Technical Service Bulletin

01 Engine Crankcase breather Whistling Noise and DTC P227900 warning light ON

01 23 59 2069351/3 June 28, 2023. Supersedes Technical Service Bulletin Group 01 number 23-44 dated February 13, 2023, for reasons listed below.

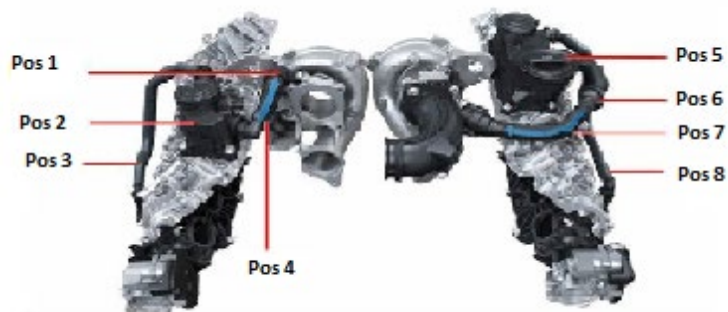
In this case, replace the full load breather line for cylinder bank 1.

1. Do not replace the oil separator for bank 1 or bank 2 or the part load breather lines.
2. Please refer to image of the crankcase breather from the Self Study Program 920493 as a guide.

Item 4: Full load breather line for bank 1 (Replacement required)

Improved crankcase full load breather line for bank 1 have been implemented in production between the end of Q2 2021 and the start of Q4 2021, depending on engine version. See table below:
